FINAL PLAT OF
"WOODROME ADDITION"
 SEDGWICK COUNTY, KANSAS
 (SE1/4 OF SEC. 23, T28S, R1W OF THE 6TH P.M.)

RE: S/D 98-78 - Final Plat of WOODROME ADDITION

S/D 98-78 - Preliminary Plat of WOODROME ADDITION

CASE NUMBER: S/D 98-78 - WOODROME ADDITION

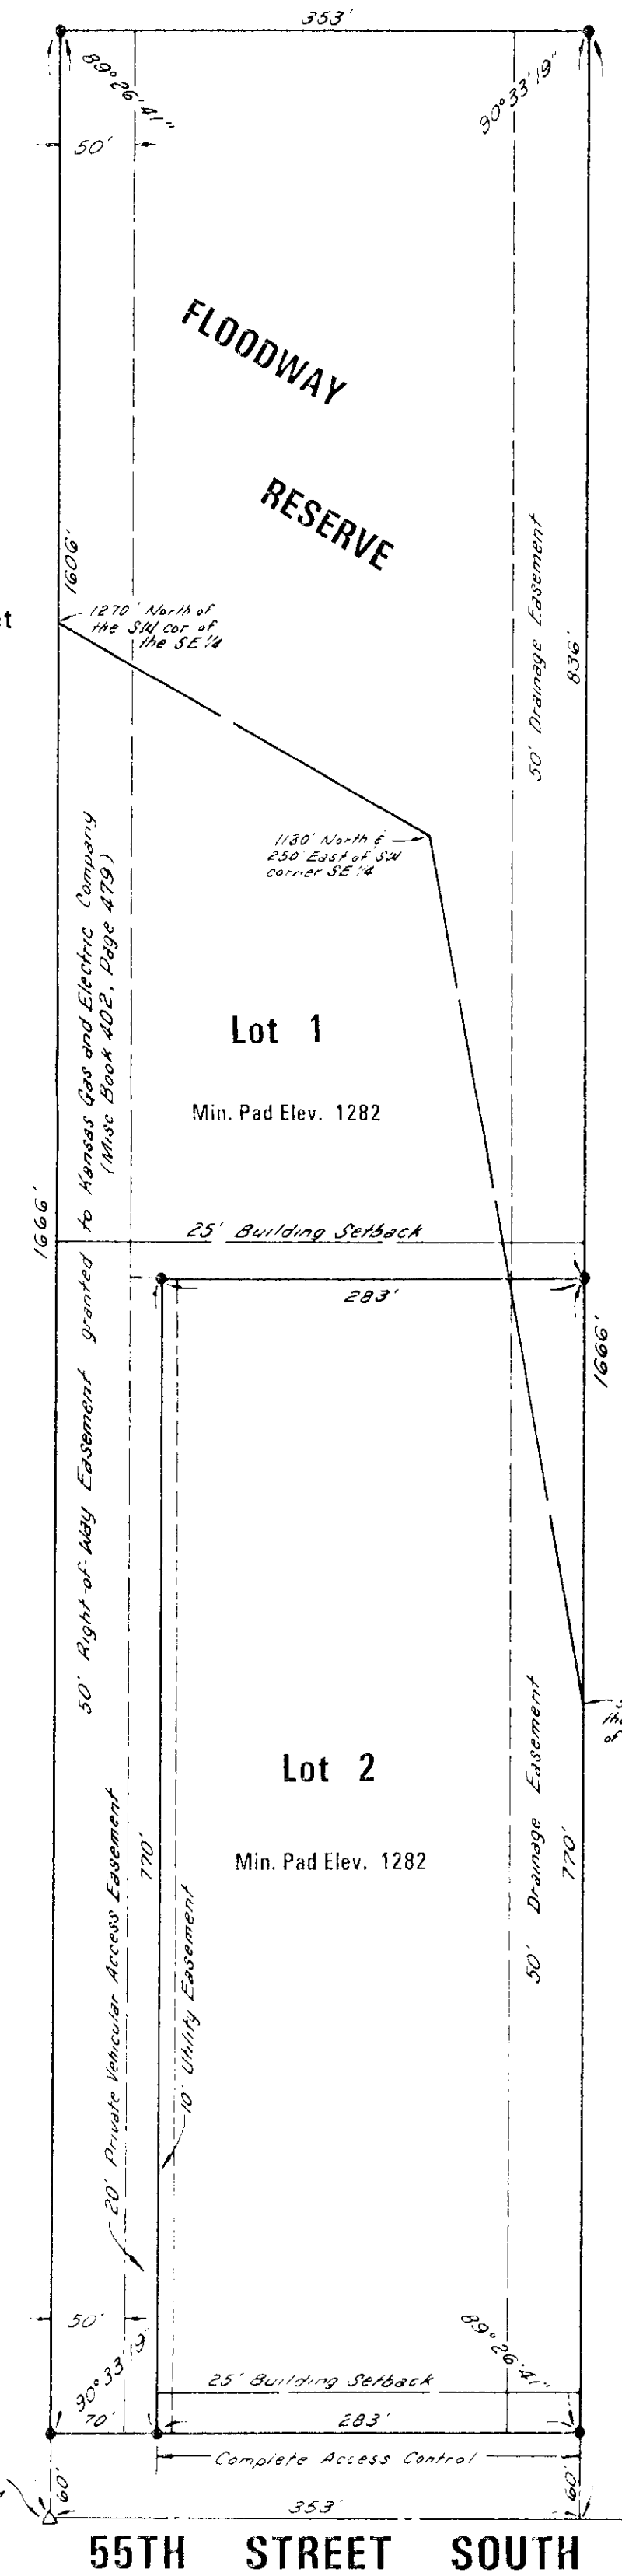
- C. County Engineering needs to comment on the status of the applicant's drainage plan. If any minimum building pad elevations are required for this site, these elevations shall be noted on the face of the plat and also referenced in the plat's text. The drainage plan is approved.

- F. On the final plat, both the face of the plat and the plat's text shall denote access controls along 55th St. South. County Engineering requests 100 feet of

complete access control along the east 100 feet of the lot. One access opening per lot is permitted.

- G. Under SF-20 zoning, a minimum lot width of 100-feet is required, which is measured at the building setback line. Lot 1 shall denote a building setback line located 25 feet from the north line of Lot 2.

- H. **County Fire** needs to comment on the acceptability of a 770-foot private-type drive for emergency access to Lot 1. **County Fire requires that the road be built according to Fire Department access specifications.**

- R. The representatives from the utility companies should be prepared to comment on the need for any additional utility easements to be platted on this property. **Southwestern Bell requests additional easements which have been denoted on the final plat.**

The applicant has platted completed access control along Lot 2 and an access easement across Lot 1. A cross-lot access easement agreement will need to be established by separate instrument stating which properties are benefited by the easement, which properties are responsible for initial construction and maintenance of the driving surface within the easement, and that obstruction of the easement is prohibited.

The requested setback line has been denoted on the final plat.
